**Westinghouse  
Electric Corporation**

July 20, 1992

Subject: Additional Information Regarding Bloomfield, NJ Facility

Figure 2  
WELL LOCATION MAP

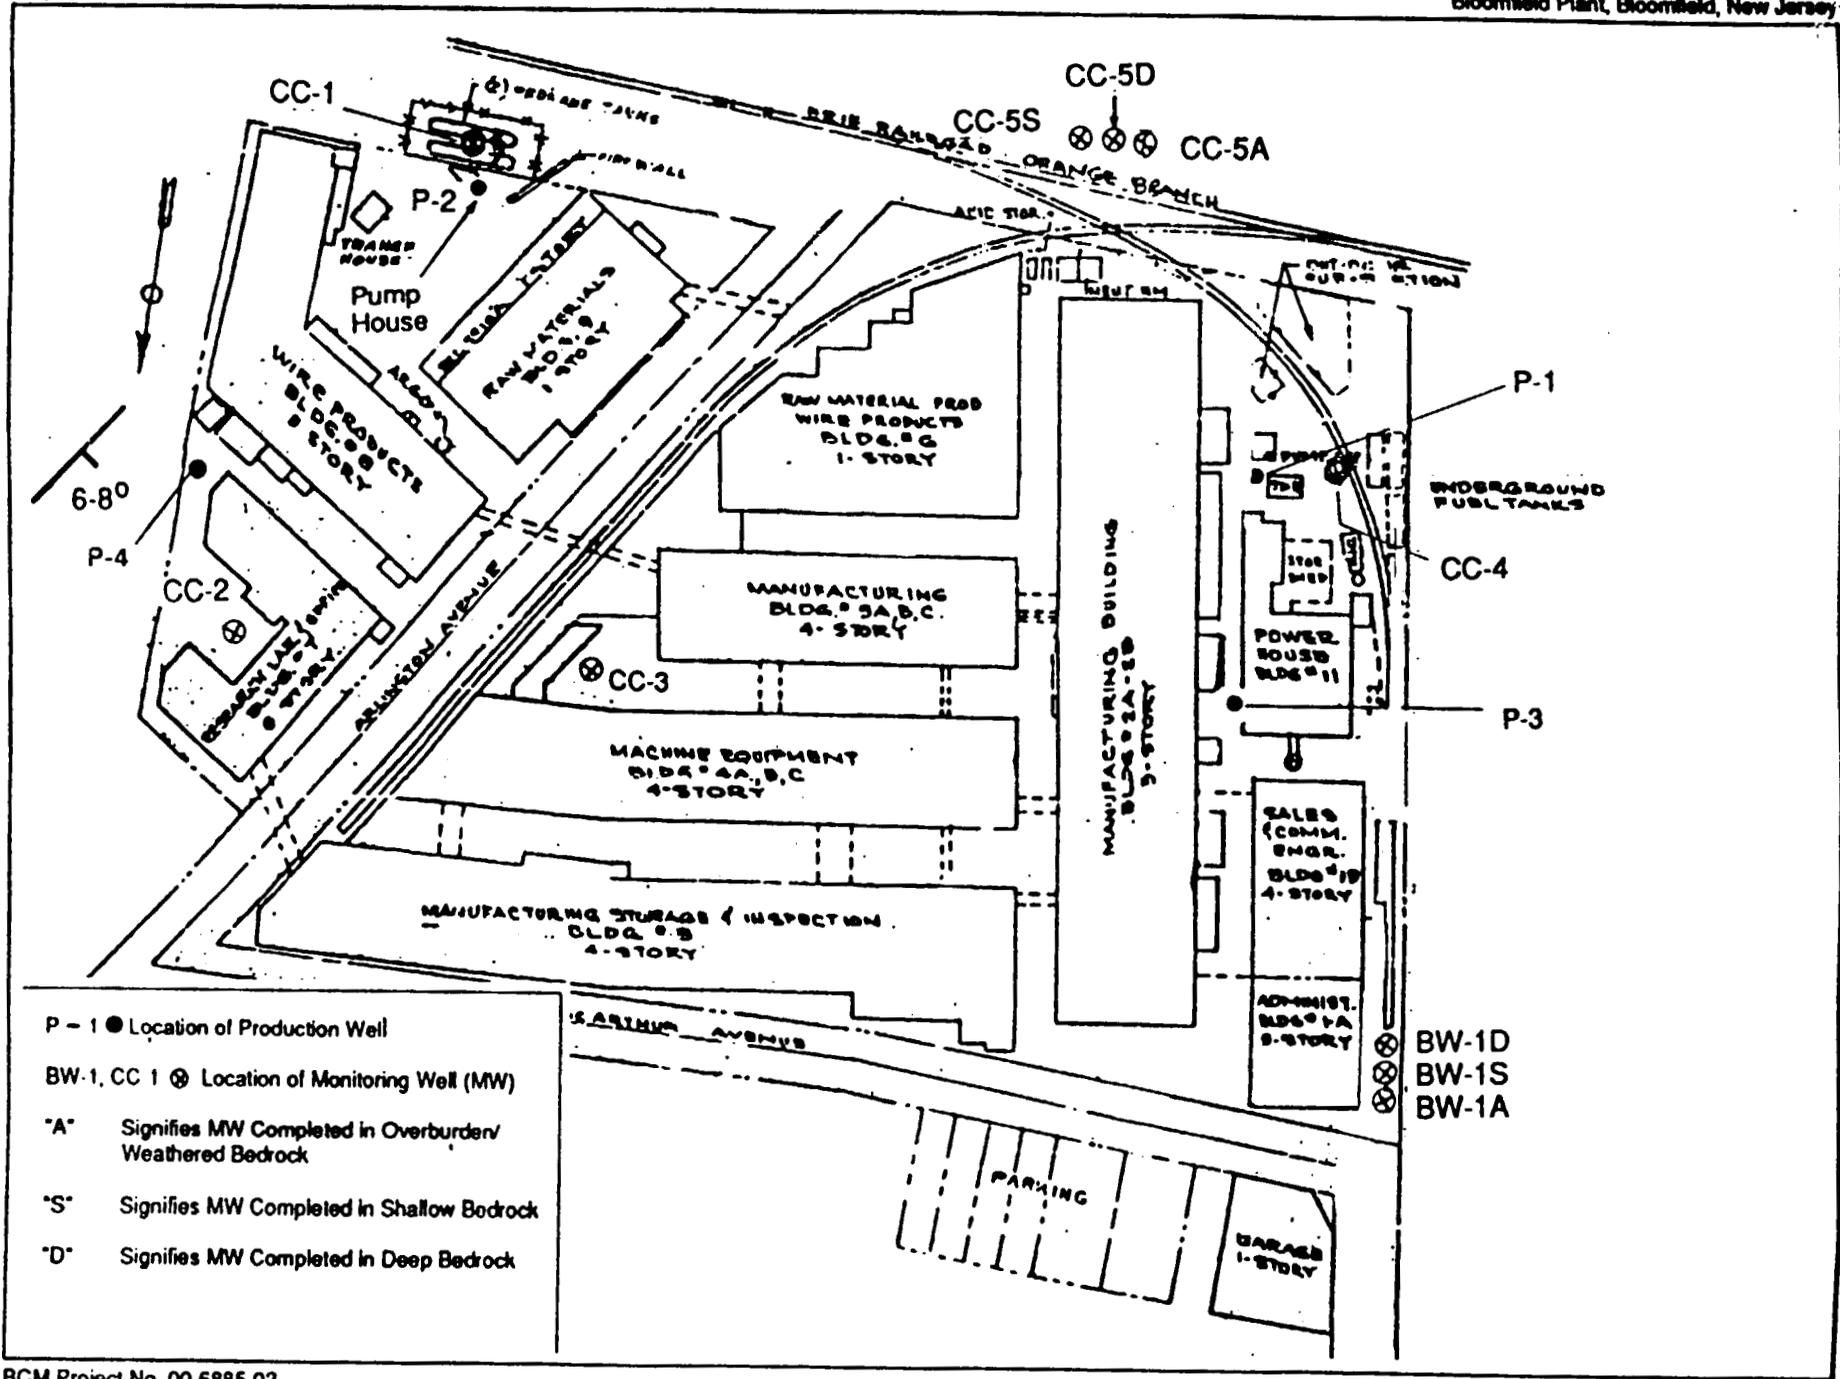
In your September 23, 1991 response to our letter of April 29, 1991, you provided two tables of results of analyses of ground water samples. Please provide a map or diagram of the locations of the monitoring wells from which these samples were obtained, the dates the samples were obtained and the depth where each of the samples was obtained.

Ground water samples from 2 overburden (regolith) and 7 bedrock wells at the Bloomfield site collected on May 23, 1990 were analyzed for radioactivity and select radionuclides. The results of this testing are given in the enclosed Table 11. In addition, samples from

production wells P-2, P-3, and P-4 were collected on March 11, 1986 and analyzed for gross alpha activity, total uranium activity, and total uranium concentration. These data are presented in Table 1.

The locations of all these wells are shown in the enclosed Figure 2. Wells construction data indicating the depths from which these ground water samples were collected are given in the enclosed Table 6.
